Product: CSE, see the PNC list at the end of document.

Defect: Humming Symptom - The motor work very slowly also if it is turned off.

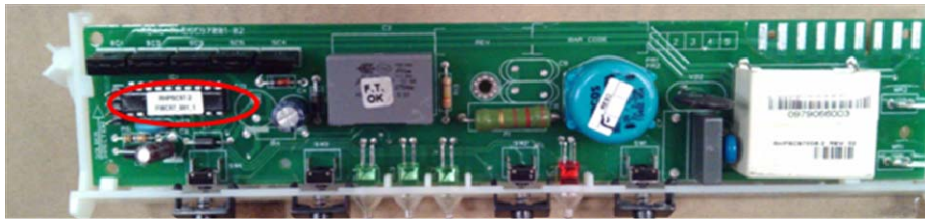
Root cause: Changed motor group on December of last year. A spike from the new motor damages the triac component on the PCB.

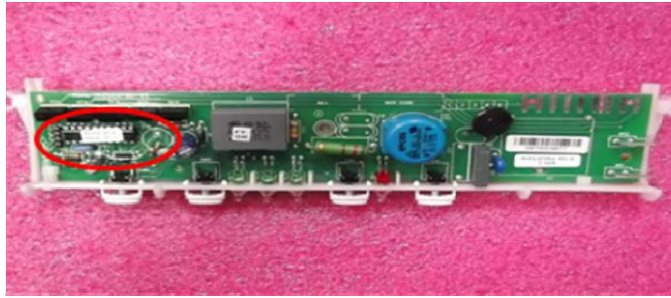
There are two existent PCB for this model and Elica BOM is readable on the plastic support (picture C). They are very similar, but they aren't interchangeable.

- A) OLD Motor group. PNC listed below.
It is also recognizable by sub-supplier code RHPSC97-2. Picture A.
- B) NEW Motor group. PNC listed below.
It is also recognizable by sub-supplier code RHPSC97-4 (hardware modification) and FWC97_001_2 (software modification). Picture B.

Solution: Starting from week 46 2012 this cooker hood model is produced with a new Control Board (changed hardware and software). This new PCB is interchangeable with the previous one of this year. All involved codes are in the tab at the end of the document.
